HISTORIC AND DESIGN REVIEW COMMISSION

HDRC CASE NO: 2022-121
ADDRESS: 535 E HUISACHE AVE
LEGAL DESCRIPTION: NCB 3090 BLK 6 LOT 28
ZONING: R-4, H
CITY COUNCIL DIST.: 1
DISTRICT: Monte Vista Historic District
APPLICANT: CEE WINKLER/WINKLER JULIE M
OWNER: WINKLER JULIE M
TYPE OF WORK: Front walkway modifications
APPLICATION RECEIVED: February 17, 2022
60-DAY REVIEW: Not applicable due to City Council Emergency Orders
CASE MANAGER: Hannah Leighner

The applicant is requesting a Certificate of Appropriateness for approval to replace the front concrete walkway and steps with a set, grouted flagstone walkway.

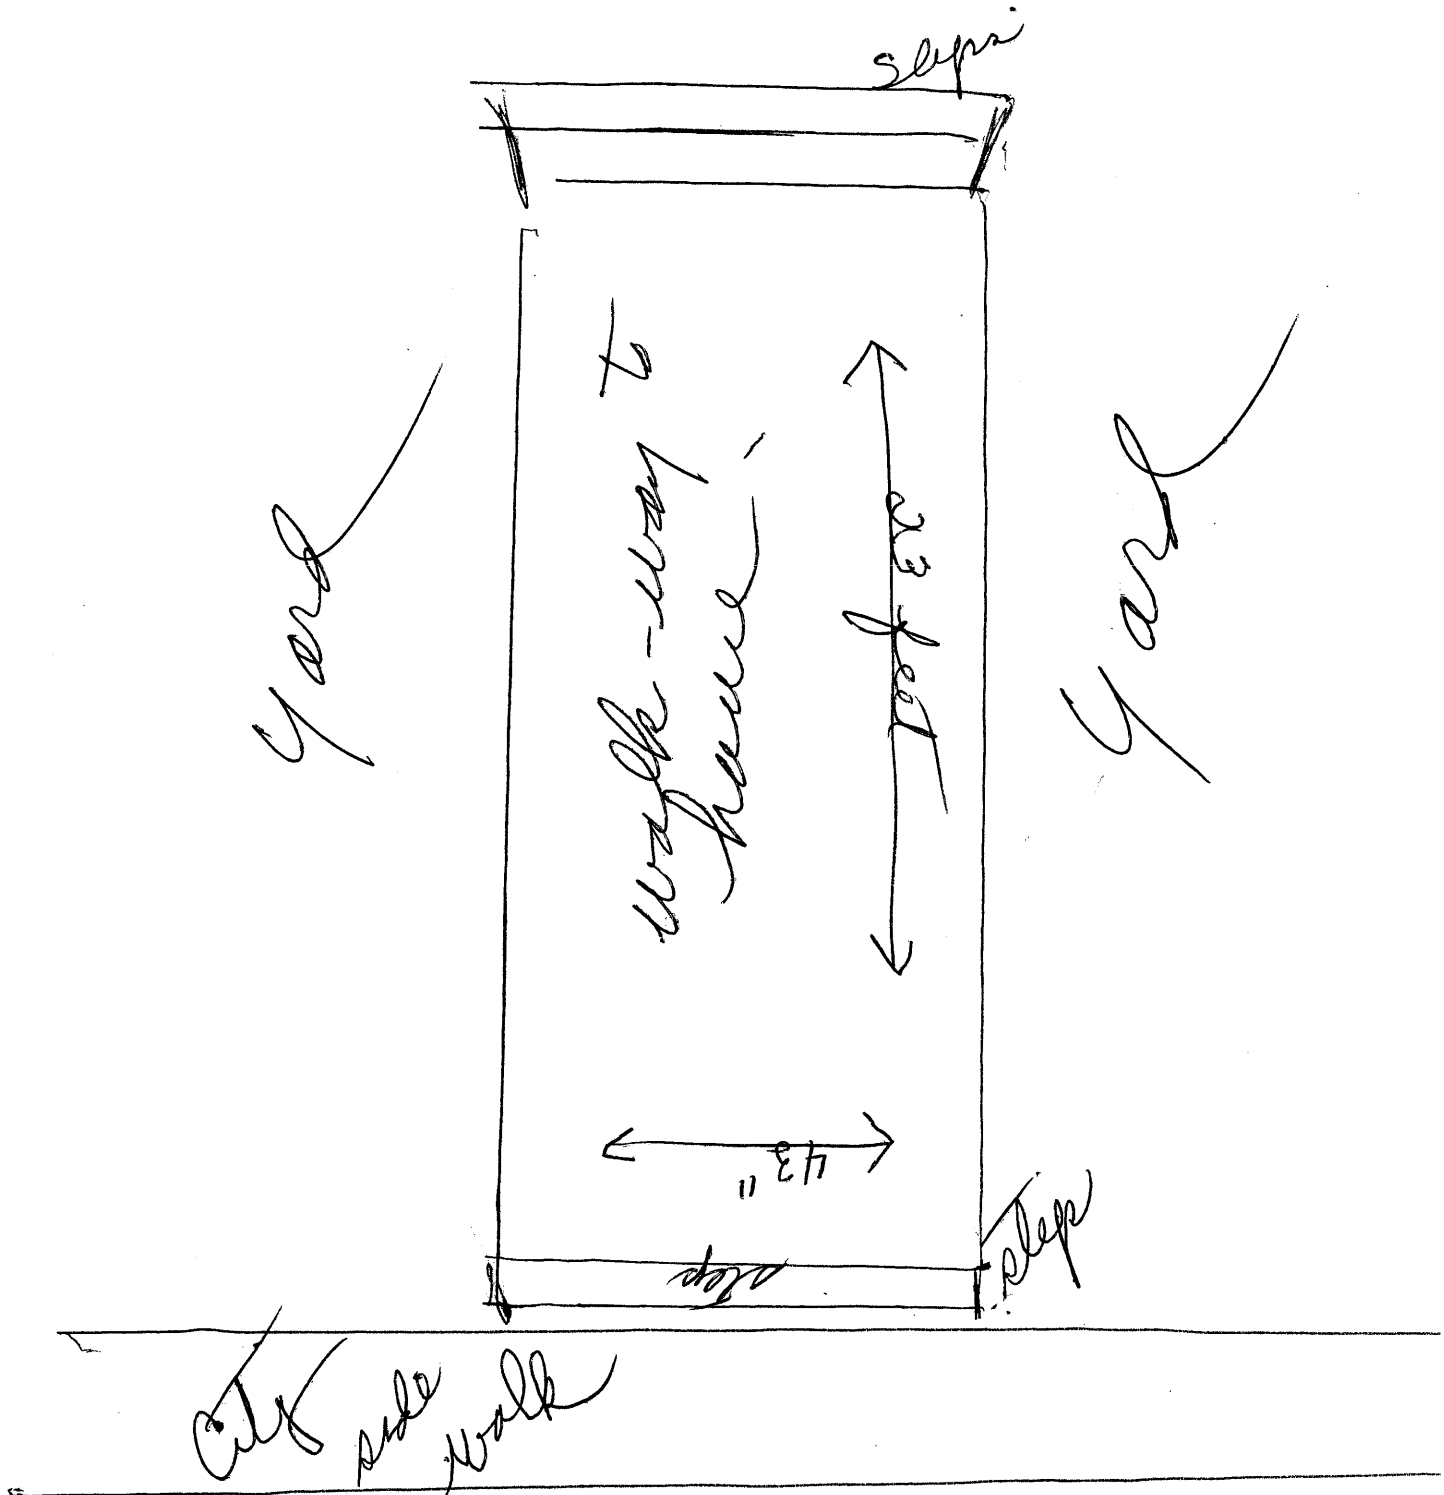
- c. **SIDEWALK REPLACEMENT** – The applicant is proposing to replace the existing poured concrete walkway and front steps with set and grouted flagstone pavers. The property is located on the 500 block of E Huisache Avenue, which maintains properties which feature poured concrete driveways and front walkways that are in similar profile and color to the existing sidewalks which run along the north and south sides of E Huisache. The Guidelines for Site Elements 5.A.i-iii state that historic sidewalks should be replaced only where beyond repair using in-kind materials, and to match the existing sidewalk in material composition and color, width, and alignment. Staff finds the replacement sidewalk to be inconsistent with these guidelines. Replacement with a poured concrete sidewalk that matches the original sidewalk would be appropriate.

Staff does not recommend approval for sidewalk replacement based on finding b. Staff recommends that the applicant install a poured concrete sidewalk that is consistent in material, dimension, profile, and color to that which was removed, and that is consistent with sidewalks that are found historically on the block.
